Addendum No. 2

Project No. 2026-20-D&O

Project: 1 Innovation Natural Gas-Fired Air Handling Unit Replacement

Figure 4 – Gas Valve Nameplate Information

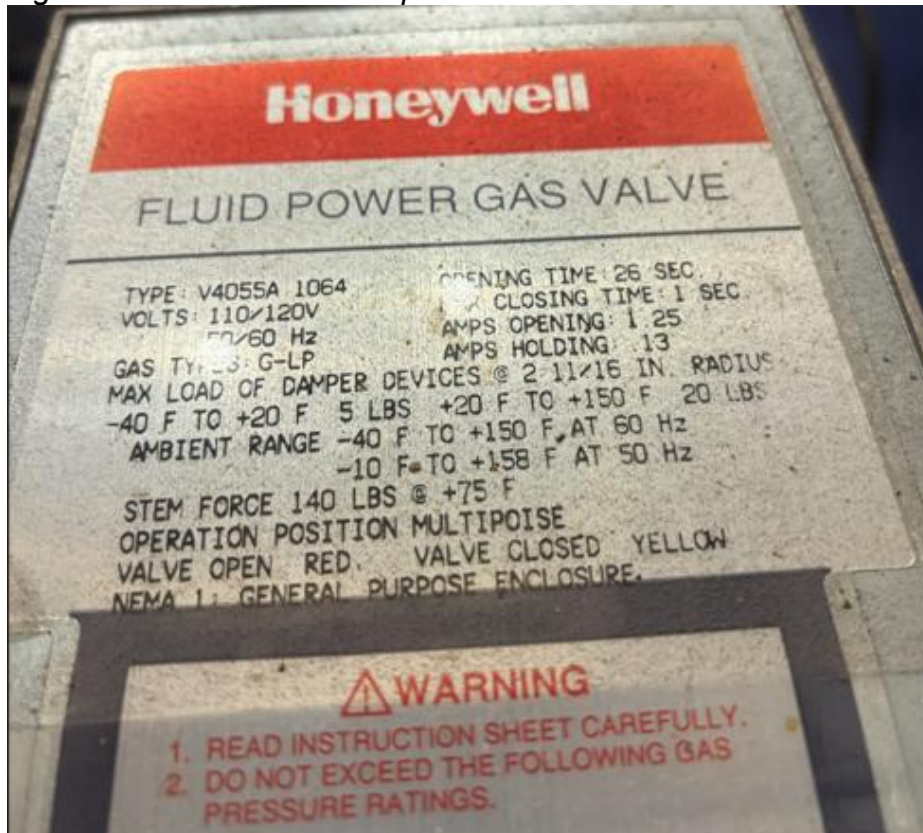
6. **Question:** Could you please provide nameplate information on the below indicated gas valve this will help indicate the available gas pressure.

Answer: Please refer to *Figure 4 and 5 Gas Valve Nameplate Information* in **Clarification** section above.
